# Request for Quotation

RFQ NUMBER
DEFK10007

LINE	QUANTITY	UOP	CAT NO.	ITEM NUMBER	UNIT PRICE	AMOUNT
				ADDENDUM #04		
				THIS ADDENDUM IS ISSUED TO MODIFY, CLARIFY, AND ADD TO THE ORIGINAL REQUEST FOR QUOTATION SPECIFICATIONS, AND ANSWER VENDOR QUESTIONS, PER THE ATTACHED DOCUMENTATION; AND EXTEND THE BID OPENING TO 12/18/09; 1:30 PM.		
				NO ADDITIONAL QUESTIONS WILL BE ACCPETED DUE TO THE TIME CONSTRAINTS FOR FUNDING OF THE PROJECT.		
				REVISED BID OPENING DATE: 12/18/2009; 1:30 PM		
0001	1	LS		968-20		
				BUILDING CONSTRUCTION		
				***** THIS IS THE END OF RFQ DEFK10007 ***** TOTAL:

The following clarifications and/or changes to the Bid Documents pertain to the New Construction associated with the New Elkins AFRC, Elkins, WV. This addendum forms a part of the Bid Documents and modifies the original drawings.

# ELKINS AFRC RFI #5

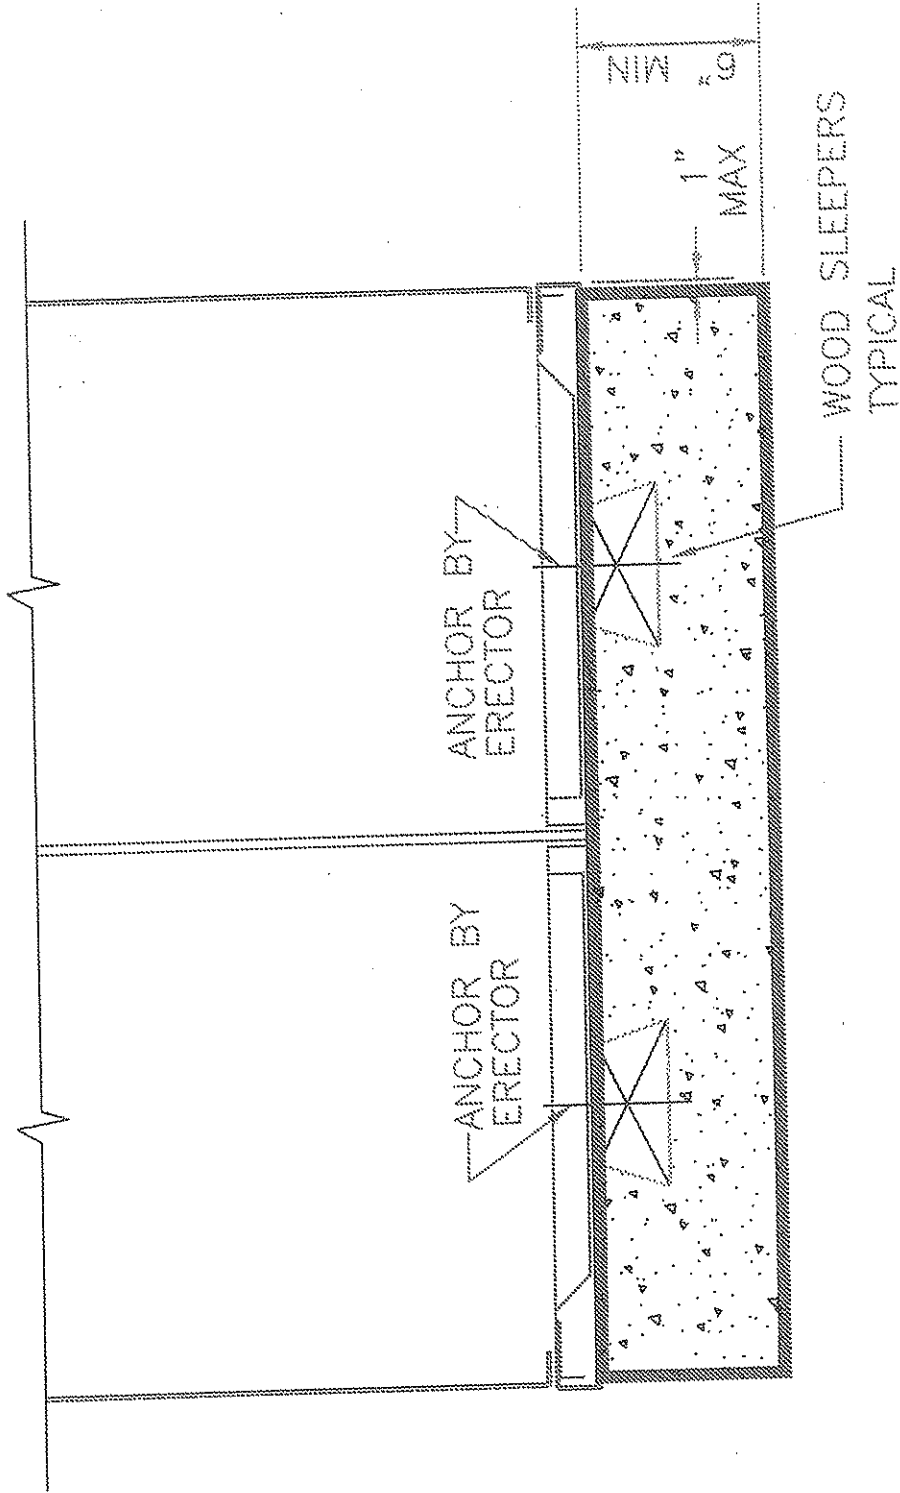
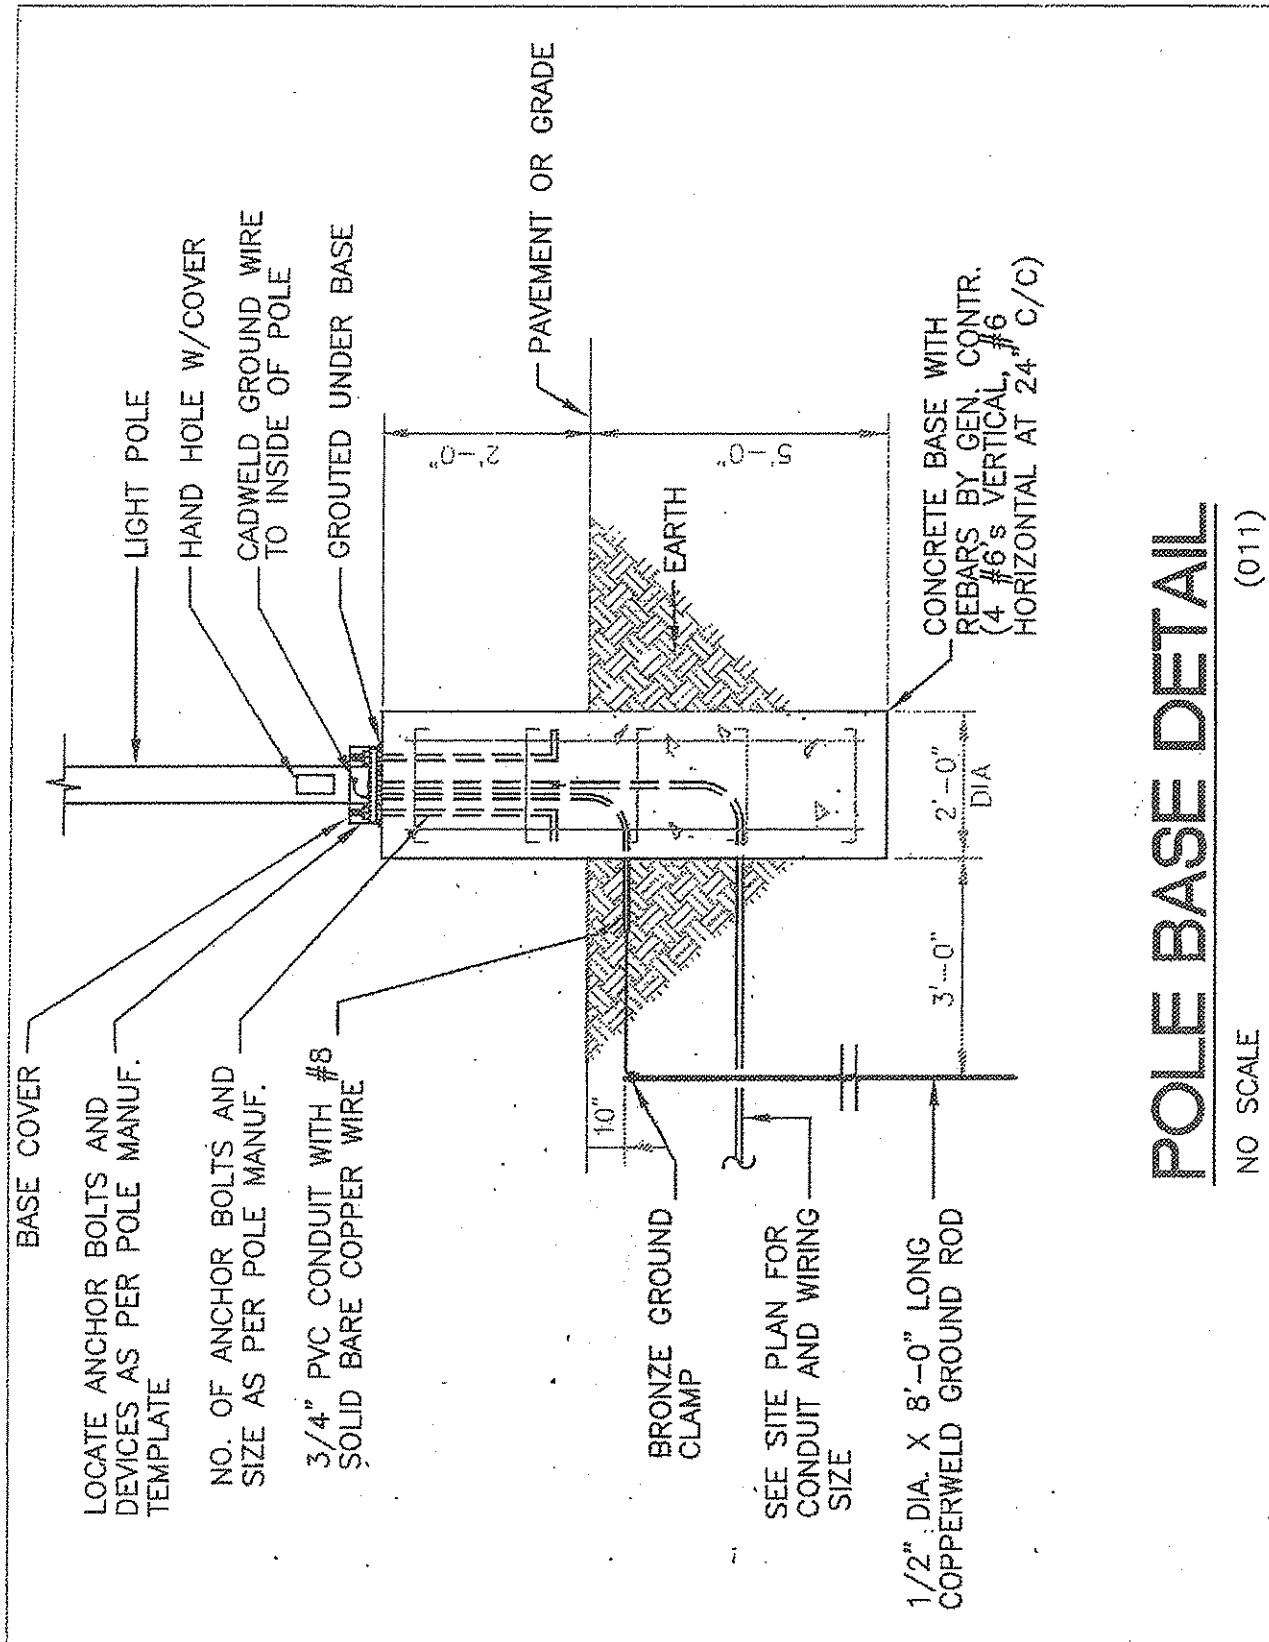
<p><u>[RFI #8]</u></p> <p>1. S-001, Foundation Note 4. "Foundations for the main AFRC Building are to bear on bedrock, over excavate as required." Bid Item #8, Over excavation, is this included in this bid item? If not, please provide an allowance due to the unquantifiable nature of this item.  <b>&gt;&gt; Bid Item #8 is for soft spots in subgrade of fill areas and is only used upon direction from the COTR. The building and foundations are a lump sum bid item. The borings are included in the contract documents to form a basis for estimating the CLSM required for backfill up to the foundation from suitable bearing rock.</b></p>	
	<p><u>[RFI #9]</u></p> <p>1. E506, SEU-2, M-65, M-66 pole lights are not listed on the lighting fixture schedule. We also can't find any foundation details for these fixtures.  <b>&gt;&gt; Light fixtures "M65" and "M66" are included in the light fixture schedule on drawing E506. The schedule has two (2) columns. Poles to be set on elevated bases that are (typically) from 24 to 30 inches high – as per submitted detail Elec-Pole-</b></p>

NO.	ITEM DESCRIPTION	NOTES
	<p><i>Base-Detail(12-08-09).</i></p> <p>2. We request a one week bid and question cut off extension.  <b>&gt;&gt; Date extended to 15<sup>th</sup> Dec.2009.</b></p> <p><u>[RFI #10]</u></p> <p>1. A-101, Rooms 142 &amp; 143; S-101, 9/S-301, on the architectural drawings these rooms are listed as vaults. On the structural detail, 9/S-301 it shows a typical masonry wall detail. Is this correct or should it reference 7/S-301?  <b>&gt;&gt; It should reference 7/S-301</b></p> <p>2. 2/S-305, 2x Nailer, attach to HSS6x4x1/4. Does this continue on the joists as well  <b>&gt;&gt; Yes, see detail 1/S-301</b></p> <p><u>[RFI #11]</u></p> <p>Please provide clarification for the following:</p> <p>1. Is a foundation drain required for the AFRC Building? 1/S-121 shows a foundation drain for the Workshops. Is this the only place one is required?  <b>&gt;&gt; All Arch drawings show drain. It is specified in Spec. Section 02620.</b></p> <p>2. What masonry walls receive furred out Drywall walls? A-413 Assembly Hall Elevations show masonry walls, A-801 finish schedule Finish Type E shows furring and Drywall. Many of the interior elevations do not match the finish schedule. Should we go by the interior elevations or the finish schedule?  <b>&gt;&gt;Interior Masonry walls all receive furring, except</b></p> <ul style="list-style-type: none"> <li>• <b>Assembly Hall 107,</b></li> <li>• <b>Entrance 101b</b></li> <li>• <b>Curved Wall to 102,104, 151b, 151k, 106.</b></li> <li>• <b>Wind Lobby 101a</b></li> <li>• <b>Curved Wall in Corridor 101c</b></li> <li>• <b>Storage 107a &amp; 107b.</b></li> <li>• <b>Stores / Vaults 141, 142, 143 &amp; 144.</b></li> <li>• <b>Mech. &amp; Caretaker 111 &amp; 111a.</b></li> <li>• <b>Contr. Waste 010</b></li> </ul> <p>3. Specifications, 09720, Wall Coverings, none are shown on the finish schedule. Is there any Wall Coverings, and if so, where do they go?  <b>&gt;&gt; No wall coverings omit specification 09720 in its entirety.</b></p>
